U. S. NUCLEAR REGULATORY COMMISSION

Report Nos. 50-528/92-23, 50-529/92-23, and 50-530/92-23

Facility Name Palo Verde Nuclear Generating Station
Units 1, 2, and 3

Areas Inspected: Special inspection of the circumstances surrounding a Unit 1 containment isolation check valve found improperly assembled on March 18, 1992. This condition was documented by Unit 1 Licensee Event Report 92-005. Inspection Procedure 92700 was used as guidance during this inspection.

ATTACHMENT 1

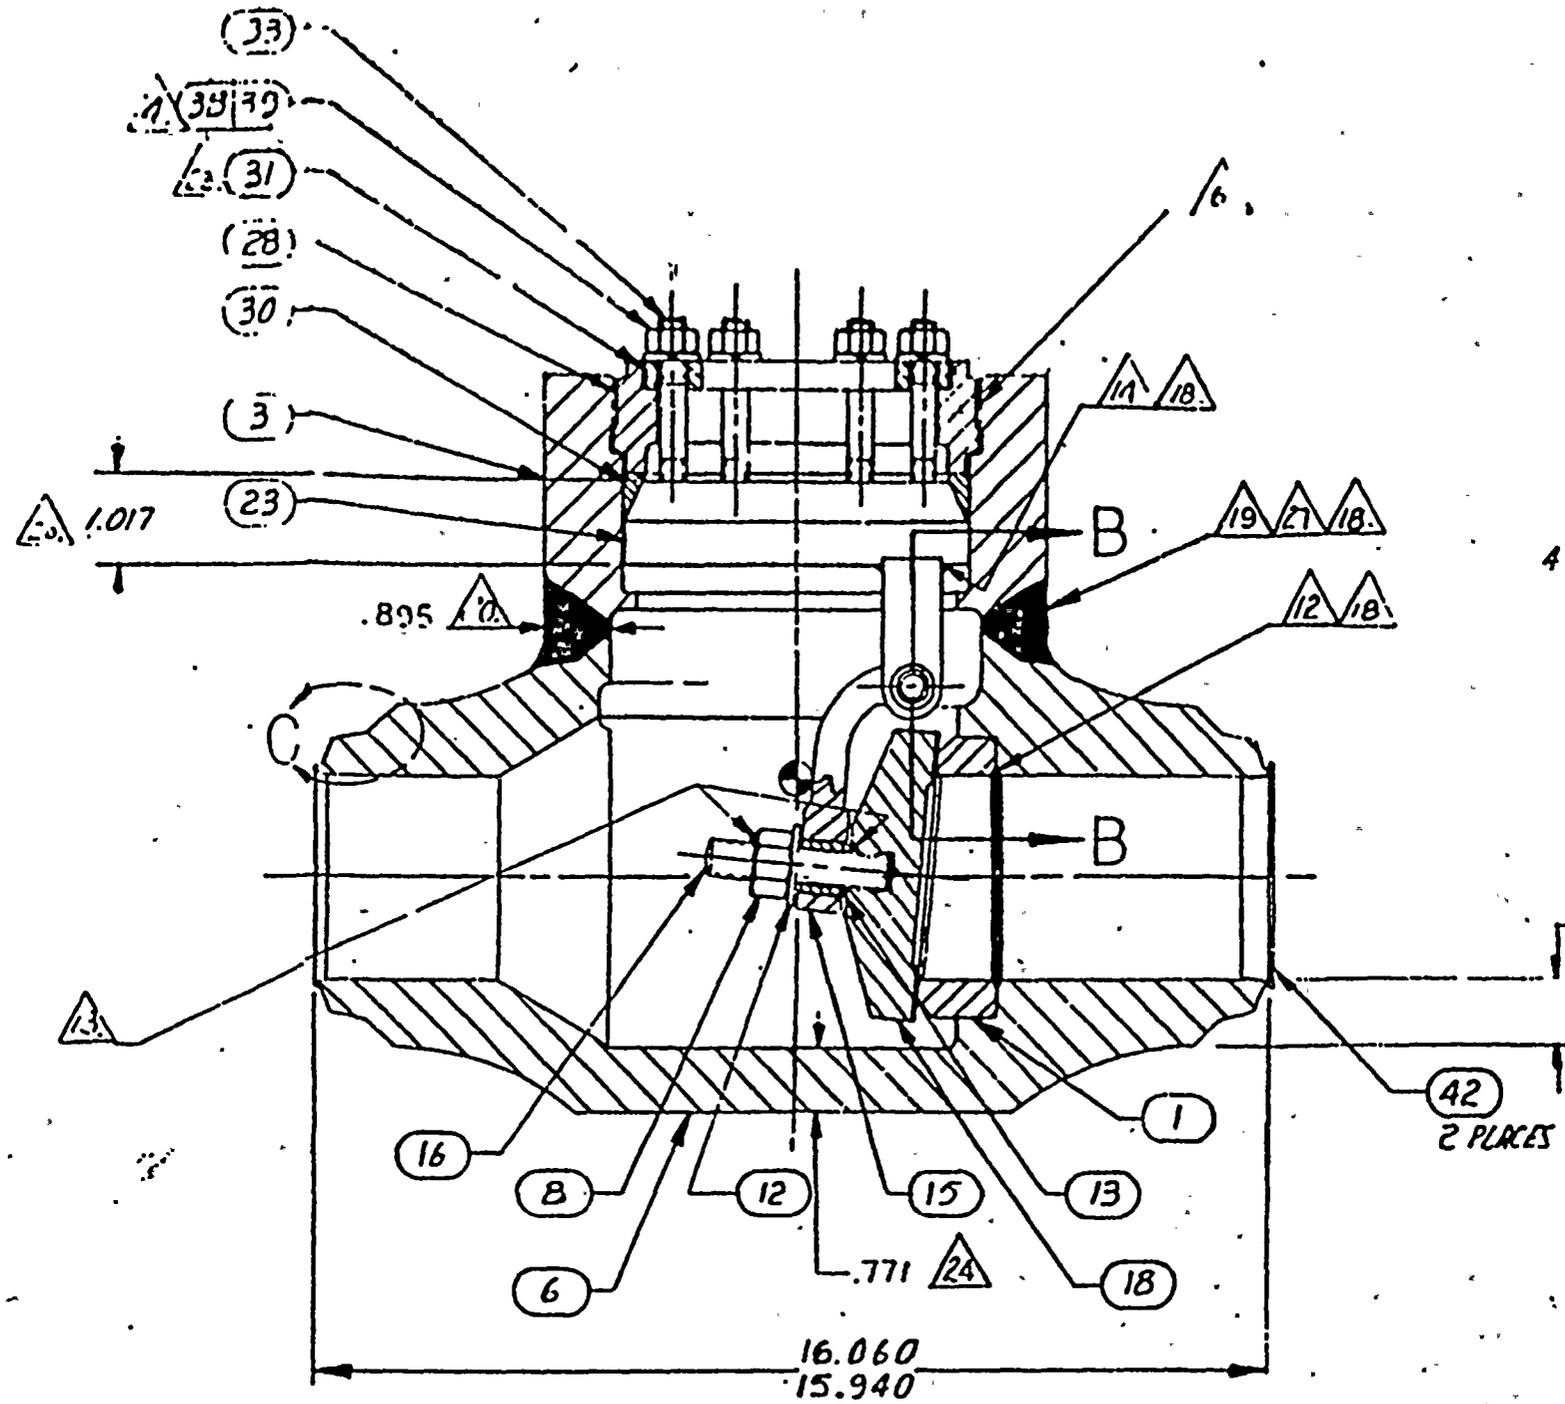
Unit 1 valve SIE-V133 was found to have its bonnet assembly installed approximately 160 degrees from normal alignment. The valve was manufactured by Borg-Warner and is a three inch swing check, model 77700. The bonnet assembly includes the attached valve disc, and the bonnet assembly is secured to the valve body with a bonnet retainer held by studs, nuts, and washers. A silver plated seal between the bonnet and valve body provides leakage protection. The valve design allows the bonnet assembly to be rotated in the valve body when the retainer and seal are not present. Attachment 1 depicts the valve assembly.

The inspector reviewed the WOs associated with the disassembly of SIE-V133 and noted that there were no specific instructions for marking the line from a valve stud to the body. The inspector noted that this action was critical as mismarking could allow the valve to be reassembled in the wrong orientation. The licensee indicated that this action had been considered to be within the skill of the

craft. The inspector also noted that the sequence of WO steps was different than specified by the vendor manual. The first step for disassembly in the Borg-Warner manual was to mark the body-to-bonnet orientation. The licensee's WOs marked the valve orientation after removal of the studs and nuts, partially unscrewing the bonnet retainer, and reinstalling the studs and nuts. The inspector questioned if some misalignment might occur while unscrewing the bonnet retainer and inadvertently rotating the bonnet assembly prior to match marking. The licensee indicated that while misalignment was possible, it would be unlikely due to the force needed to break the seal between the bonnet assembly and the valve body. The licensee added that the seal in SIE-V133 did not show any markings to indicate that it had rotated. The inspector also noted that the Borg-Warner manual specified measurement of a seating dimension for the bonnet retainer, and the WOs did not specify making the measurement.

- 2) The maintenance procedure did not provide sufficient detail for marking the orientation of the valve during disassembly. The procedure relied on the skill of the craft to ensure that this action was successfully accomplished. In addition, the maintenance activities did not accomplish the intended goal of proper valve reassembly.

- 4) To review the mechanical technician valve maintenance training program for needed modifications.
- 5) To develop a Model Work Order for disassembly of silver seal bonnet valves.

FIGURE 1

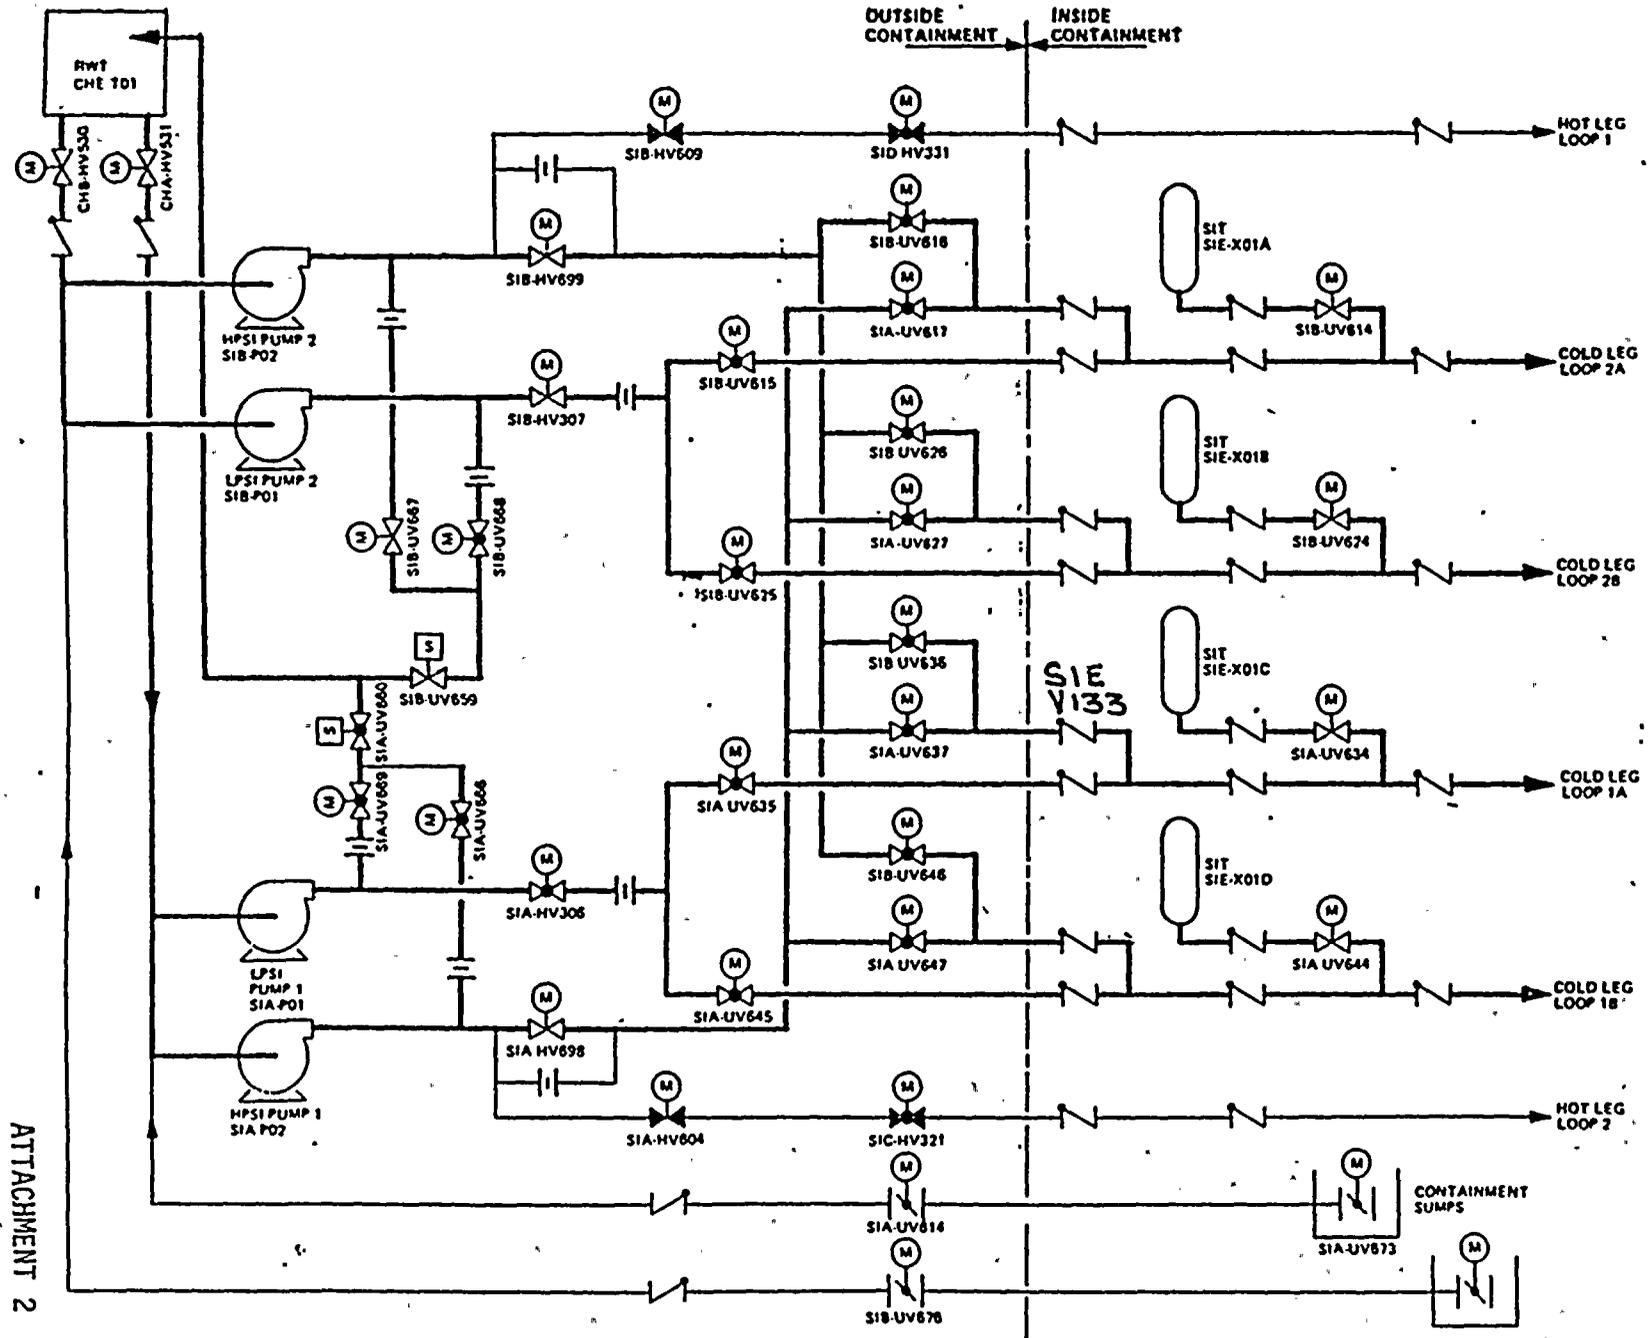
SIE-V133 is located in the high pressure safety injection (HPSI) system leading to reactor coolant system loop 1A. The valve is located inside of containment, within five feet of the containment wall. Upstream of the valve, and outside of containment, the two HPSI trains join to form one line. A motor operated valve (MOV) is located outside of containment in each of the HPSI trains. Downstream of SIE-V133, the low pressure safety injection (LPSI) system connects to the injection piping. Attachment 2 depicts the location of the check valve in the safety injection system.

The inspector noted that while the surveillance procedure would test that valve SIE-V133 would pass flow, it would not test that the valve provided isolation capability. The inspector discussed the function of SIE-V133 with various licensee personnel including a component engineer, system engineers and an engineer responsible for the test procedure. Licensee personnel indicated that the function of the valve was to open after safety injection initiated. These personnel did not indicate that the valve had a design feature to shut for the purpose of containment isolation.

The Palo Verde UFSAR did not appear to credit SIE-V133 with an isolation function since it was always assumed to be open for safety injection flow throughout any analyzed accident. Even if one train of HPSI sustained total failure (single failure criteria), system design would continue to provide opposite train flow through the penetration. The inspector noted that the CESSAR stated that check valve failures were not considered credible and therefore, analysis
